Mounting kit upgrade for the BR/BI/BL/BP series tanks

WAS	BECOMES
BL / BP series 	
BI / BR series

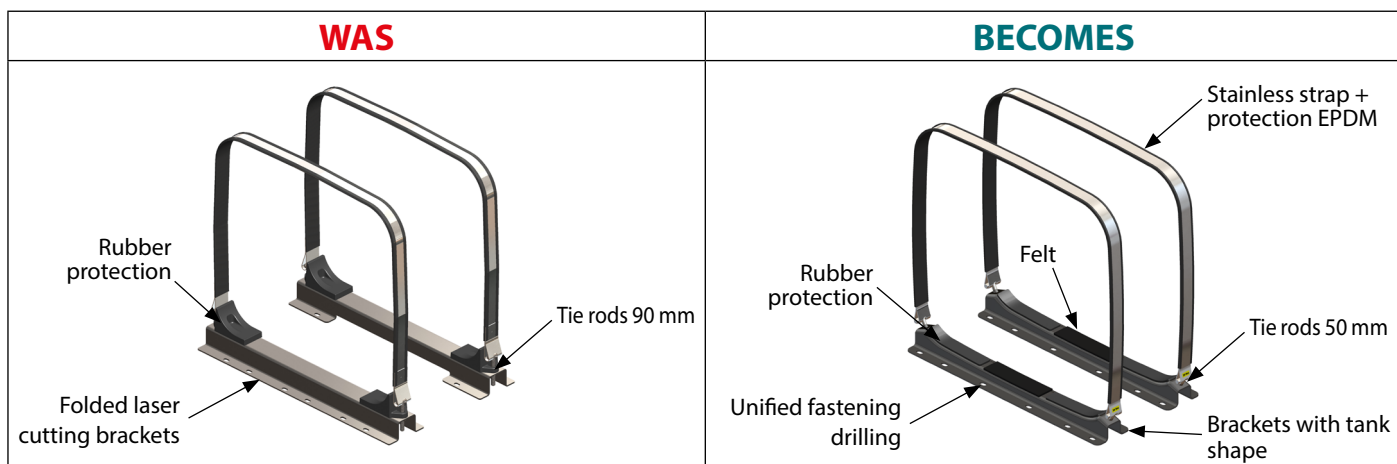
We are pleased to inform you that the BR/BP/BL/BI series of tank mounting kits has been updated with the introduction of a new support with a special design. This change has been made following the need of constant improvements of the quality of our products, adapting them to the technical equipment of the new vehicle ranges.

WAS:

135903BRRX0
135903BIRX0
135903BLRX0
135903BPRX0

BECOMES:

135903BRRX1
135903BIRX1
135903BLRX2
135903BPRX1

The bands are not compatible with the previous ones.

The new drilling allowed us to integrate the perforations of the new frames recently introduced on the market, thus avoiding the need to manage specific supports or even worse having to drill the frame.
